Access Compliance Report

Public Rights-of-Way (Curb Ramps)

Intersection ID: N/A	Main Street: ARBOR_LOOP_DR	Cross Street: POTOMAC_RIVER_PY	Location: SW
ADA ID: 004EABFF7E5C	Ramp Type: Directional1	Initial Pass/Fail: Fail	Overall Compliance: No
		Severity Score: 1.25

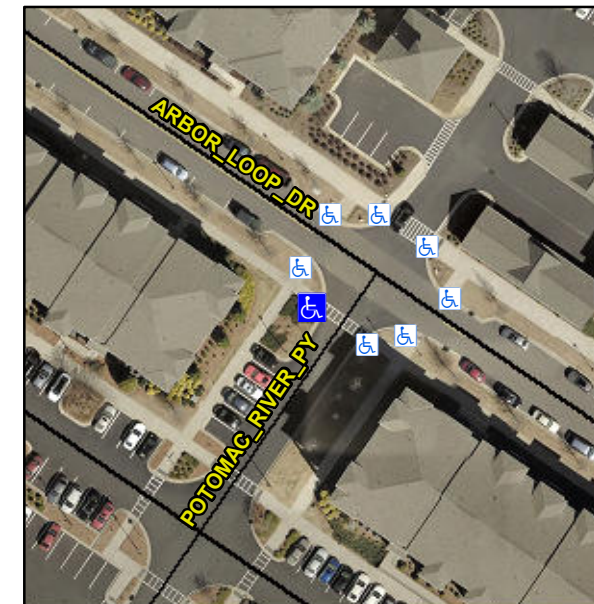
R304.5.3

Compliance	Description	Data	Compliance	Description	Data
N/A	Ramp Length (in)	172.0	N/A	Grade Break?	N/A
Yes	Ramp Width (in)	71.0	N/A	Grade Break Slope (%)	0.0
Yes	Ramp Slope (%)	5.6	N/A	Grade Break XSlope (%)	0.0
No	Ramp XSlope (%)	2.3			
N/A	Flare Type LT	N/A	N/A	Flare Type RT	N/A
N/A	Flare Slope LT (%)	N/A	N/A	Flare Slope RT (%)	0.0
N/A	Flare Traversable LT?	N/A	N/A	Flare Traversable RT?	N/A
N/A	Landing Length (in)	0.0	N/A	DWS Provided?	N/A
N/A	Landing Width (in)	0.0	N/A	DWS Contrast?	N/A
N/A	Landing Slope (%)	0.0	N/A	DWS Length (in)	N/A
N/A	Landing X Slope (%)	0.0	N/A	DWS Full Width?	N/A
N/A	Landing Curb? (Y/N)	N/A	N/A	DWS Offset LT (in)	N/A
N/A	Shared Landing?	N/A	N/A	DWS Offset RT (in)	N/A
N/A	Gutter Ponding?	0.0	N/A	Gutter Slope (%)	N/A
N/A	Gutter Lip Ht (in)	0.0	N/A	Gutter X Slope (%)	N/A
N/A	Painted X Walk1?	Yes		Road Slope (%)	0.5
	X Walk 1 Direction	To E		Road X Slope (%)	3.5
	X Walk 1 Width (in)	63.0		Clear Space?	N/A

Remove & Replace Entire Ramp.
